PUC Docket Nos. ET6675/CN-12-1053
and ET6675/TL-12-1337
OAH Docket No. 60-2500-30782
Middleton Rebuttal

FEIS ID #7

7-50

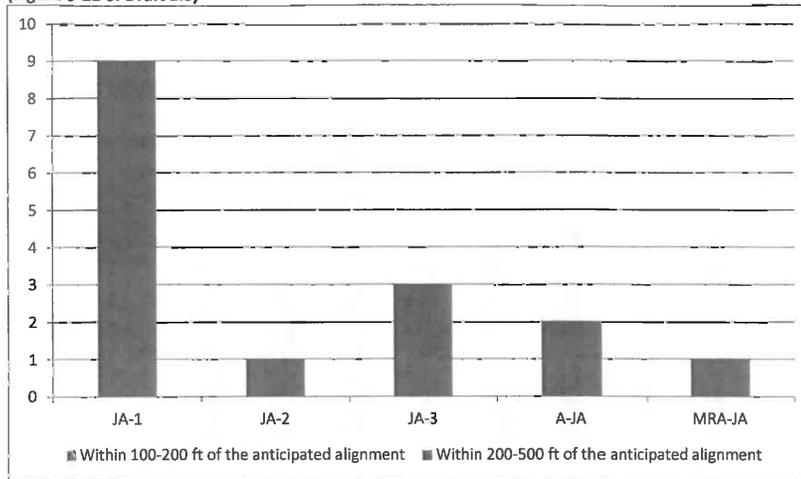
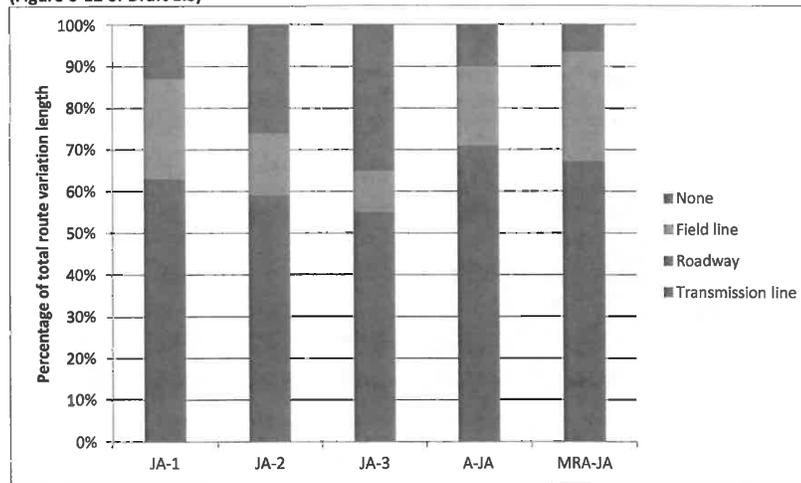
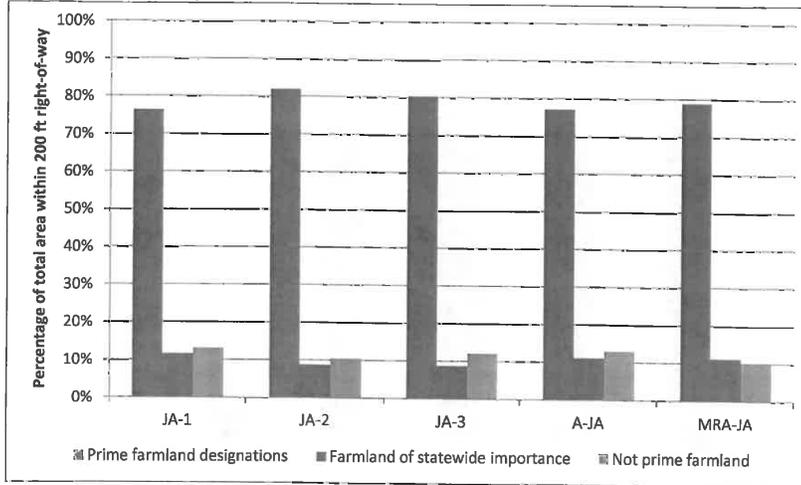
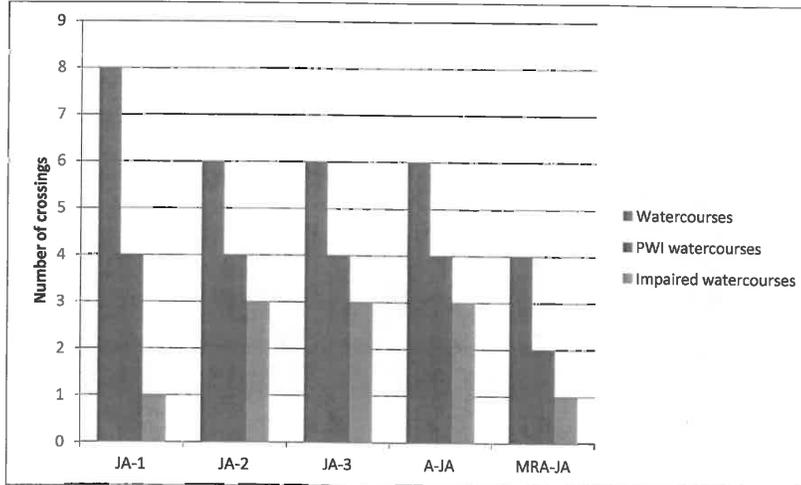
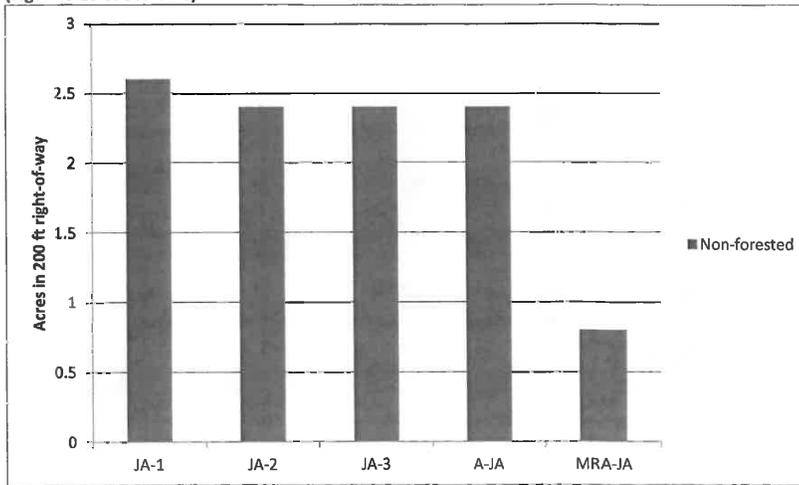
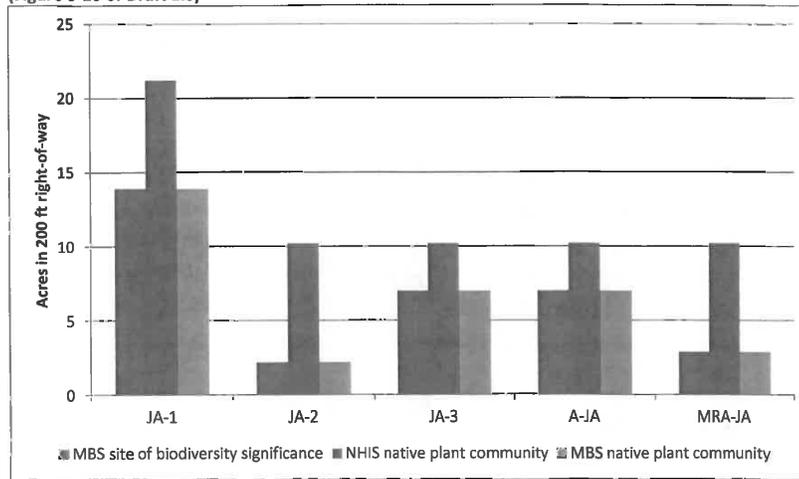
7 • Figure 7-3, JA-2, Land-Based Economies/Agriculture – In my
8 opinion, this should be categorized as “minimal to moderate” not
9 “minimal.” JA-2 crosses through the center of several fields to the
10 north of 820th Street. Other routing options that cross through fields
11 instead of following existing linear features have been categorized as
12 minimal to moderate in Chapter 7.

13 • Figure 7-3, JA-2, Use or paralleling of existing ROWs – In my
14 opinion, this should be categorized as minimal to moderate, not
15 minimal. Unlike JA-1 and A-JA, which follow 820th Street in this
16 area, JA-2 crosses through fields. Although it does follow field lines
17 in a few instances, those are not existing rights-of-way, but are what
18 I would consider a different category under the Commission’s
19 routing factors in Rule 7850.4100, Subdivision H.

20 • Figure 7-3, JA-1, Natural Environment / Flora and Fauna – In my
21 opinion and based on Map 6-14 of the Draft EIS, JA-1 should be
22 categorized as moderate. JA-1 extends through native plant
23 communities on the west and east side of the Des Moines River in
24 addition to crossing through two National Heritage Information

Though route variation JA-2 crosses through several fields north of 820th St., it also utilizes the existing 161 kV line for the greatest extent. Because of this utilization of existing transmission line ROW, EERA staff believes that JA-2 is appropriately categorized in Figure 7-3. EERA staff appreciates that there is judgment involved in estimating relative merits and that the figures in Section 7 are limited to three categories of relative merits.

See response to comment 7-53. JA-2 is categorized as consistent with the routing factor "Use or Paralleling of Existing ROWs" for its use of transmission line ROW and field lines (see Figure 6-12).

As discussed in the introduction to Section 7, the routing factors H and J in Minnesota Rule 7850.4100 address similar issues, and for purposes of the relative merits figures in Section 7 they are considered as one, with textual comment on the use of field lines and boundaries as appropriate.

Figure 7-3 has been modified to address this comment.
